Mandatory Service Bulletin

Topic: A batch of 56 6-cylinder ignitions shipped between Feb and May of 2024 (new and serviced units) may have insufficient clearance between internal case bolts and the circuit board.

Models Affected: 200-6XL, 200-6XLF, 200-6XC

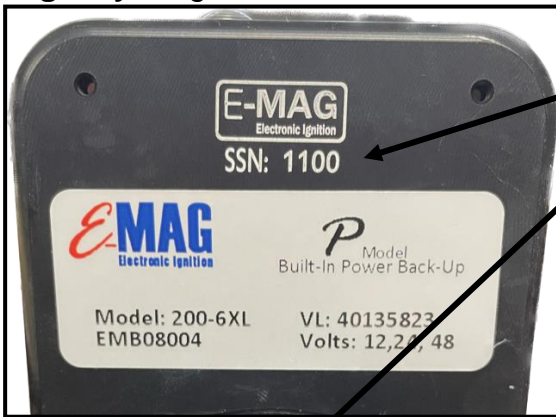
- 1) Markings – Serial numbers of new and service units affected - see below.
- 2) After service, the hardware notation on the service sticker will read “HW24” or higher (per example shown).
